INDESIT company

Model type:
AAQCF81UEE

Commercial code:
F071920

07535-05 Exploded views

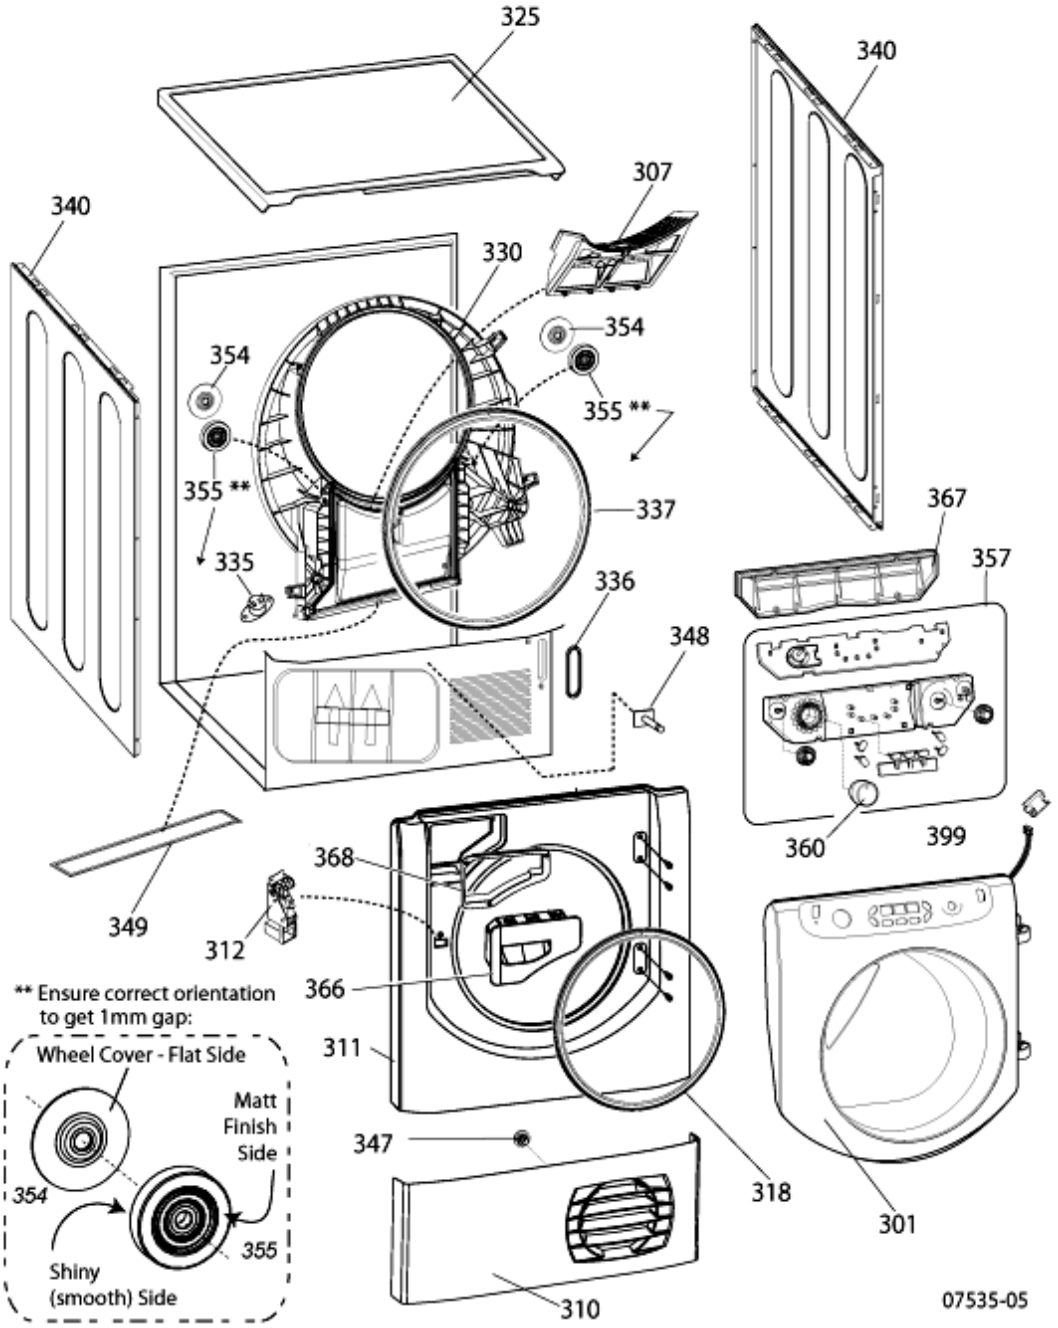
n4411g02: AQUALTIS TUMBLE DRYERS FILTERS

FROM JUNE 2011 THE FLUFF FILTER FITTED TO AQUALTIS TUMBLE DRYER CHANGED IN PRODUCTION FROM GREY TO WHITE.
SELECTED THE CORRECT PART BY DESCRIPTION IN THE PARTS LIST

n4411g03: AQUALTIS DOOR SEAL COLOUR CHANGE

ON SELECTED TUMBLE DRYERS FROM JUNE 2011 THE DOOR SEAL COLOUR CHANGED FROM GREY TO WHITE.
SELECTED THE CORRECT PART BY DESCRIPTION IN THE PARTS LIST

n4411g08: COLOUR CHANGE FRONT AIR DUCT AQUALTIS DRYER

FROM JUNE 2011 THE FRONT AIR DUCT FITTED TO AQUALTIS TUMBLE DRYERS CHANGED IN PRODUCTION FROM GREY TO WHITE.
SELECTED THE CORRECT PART BY DESCRIPTION IN THE PARTS LIST

07535-20 Exploded views

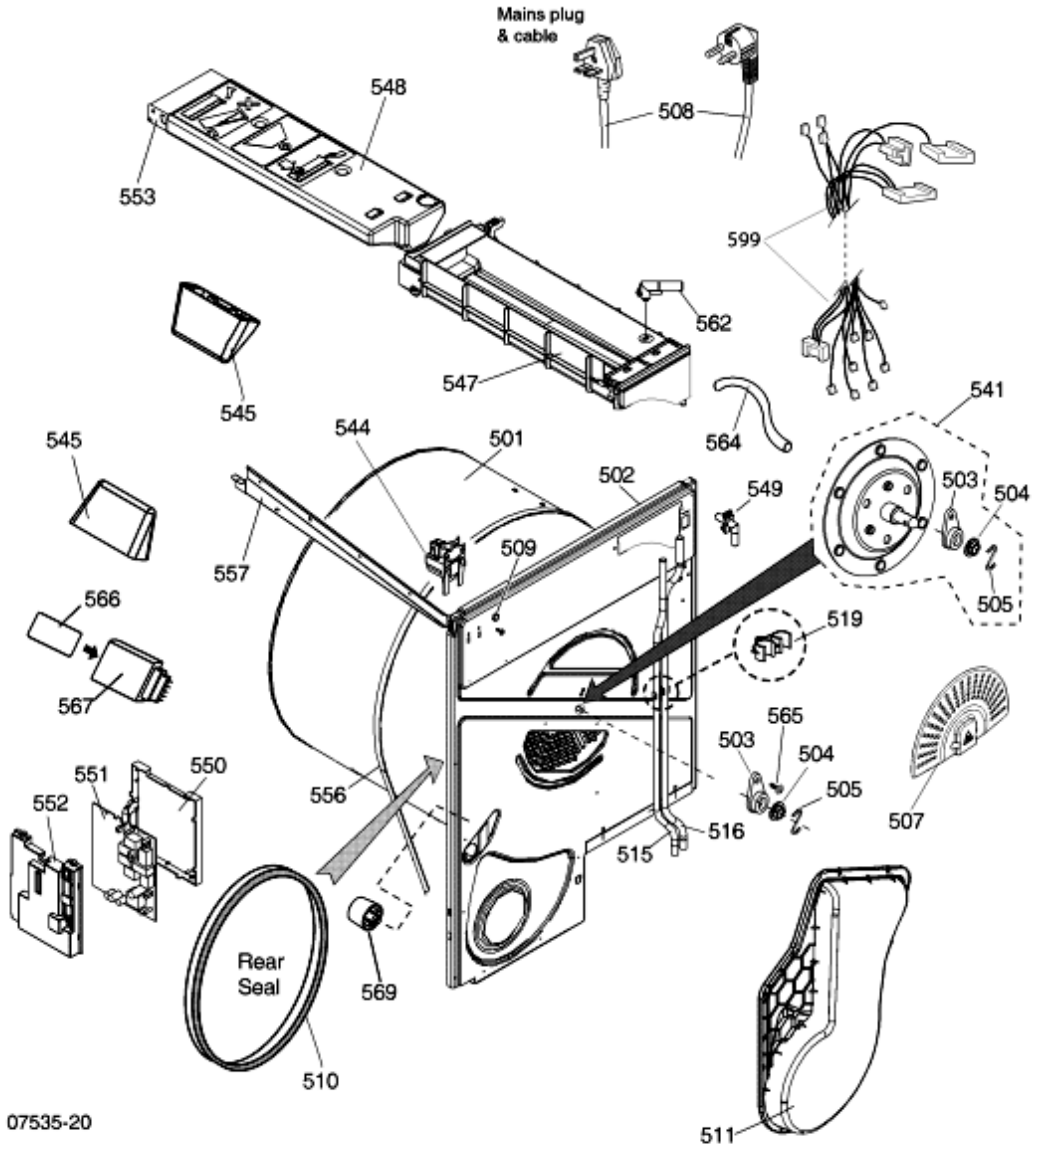
n4411h00: CHANGES TO THE CONDENSER DRUM AND LIFTERS

FROM JULY 2011 THE DRUM FITTED TO ALL CONDENSER TUMBLE DRYERS CHANGED IN PRODUCTION FROM PLAIN TO A PATTERNED FINISH.
WITH THIS CHANGE THE DRUM LIFTERS CHANGED FROM STRAIGHT TO CURVED.

THE PATTERNED DRUM AND CURVED DRUM LIFTER WILL BECOME THE SERVICE SPARE PARTS ONCE STOCK OF THE ORIGINAL DRUM AND LIFTERS ARE EXHAUISTED.

07535-25 Exploded views

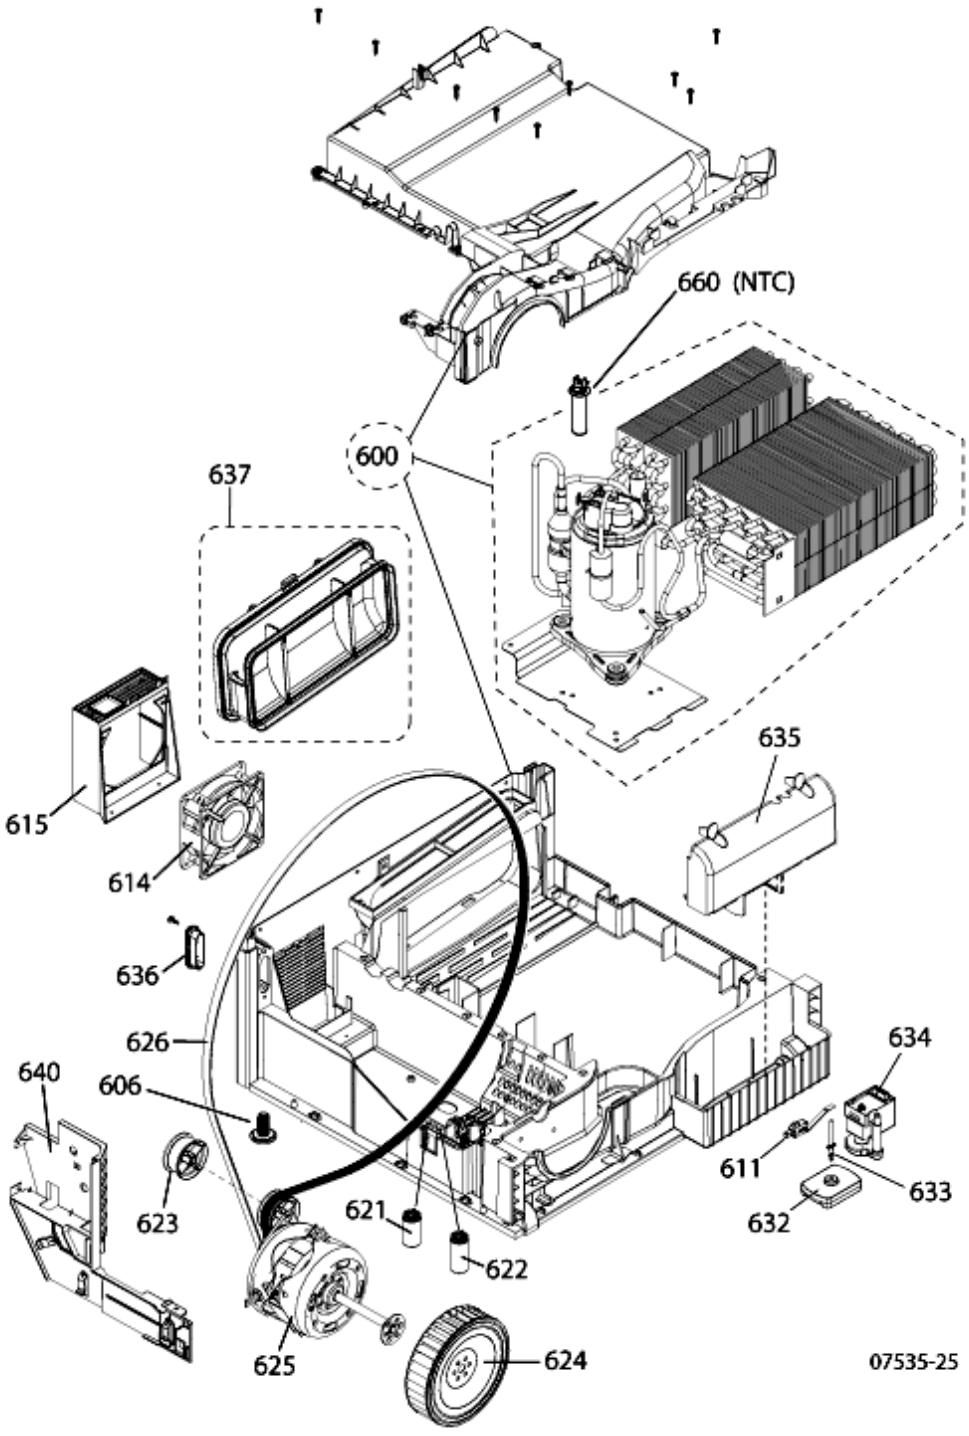
n4413i01: SERVICE HEAT PUMP BASE ASSEMBLY

All A class Heat Pump Bases are being superseded to the Yate Heat Pump Service Base. (REICHI COMPRESSOR)

When replacing an Imat (Highly Compressor) base with a Yate (REICHI COMPRESSOR) Heat pump base, if there is a 20mm Ventilation hole in the rear panel you will need to order a plug (grommet) to block off this hole.
This needs to be ordered as a seperate part. See Parts list for part number.

n4413j00: BREAKING BELTS

To overcome the issue of breaking belts the 6 Rib belt has been replaced by the 8 rib belt C00300793
